Packard

51T-48

December 21, 1951

Subject: REGULATOR POINT BURNING AND RUN-DOWN BATTERIES  
ON DELCO-REMY EQUIPPED CARS

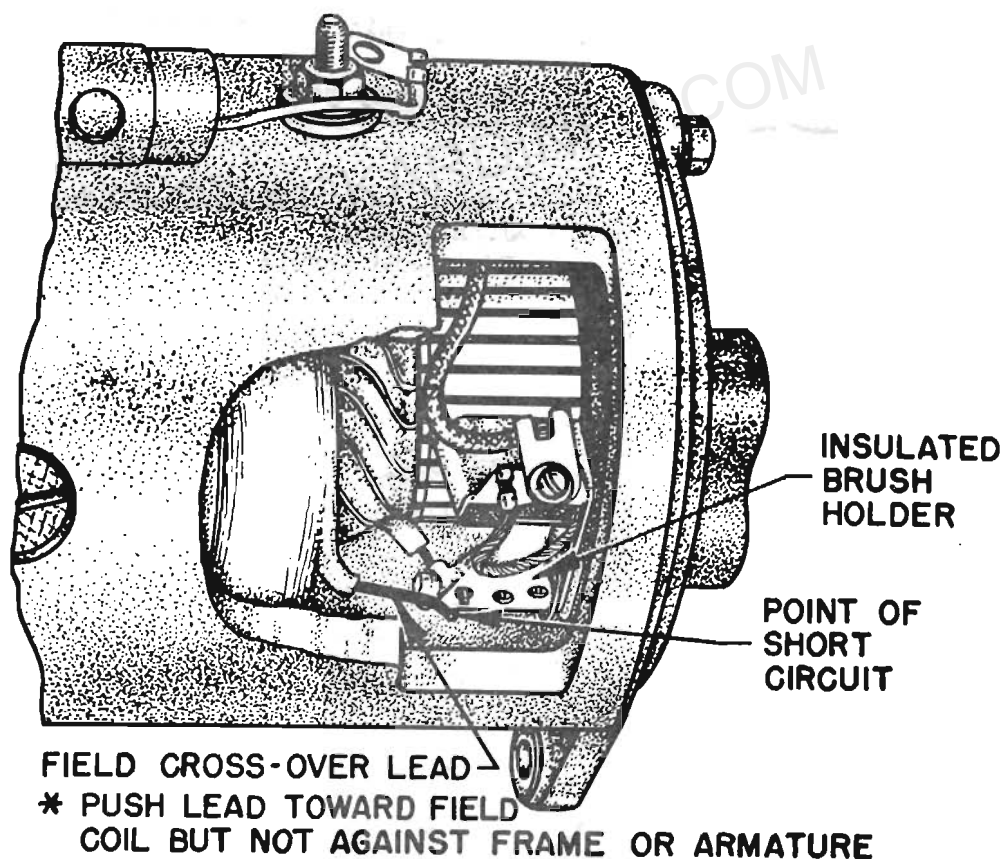
There have been some Delco-Remy generators produced since June, 1951 that may have the field coil cross-over lead touching the insulated brush holder. (See illustration.) This lead, touching the insulated brush holder, causes a short circuit at this point, which allows excessive field current to go through the regulator points, resulting in burned regulator points, high generator cut-in speeds, failure to charge, and run-down batteries.

band removed for inspection of the field cross-over lead. Push the cross-over lead away from the brush holder, toward the field coils, but not against the frame or armature.\* (See illustration.)
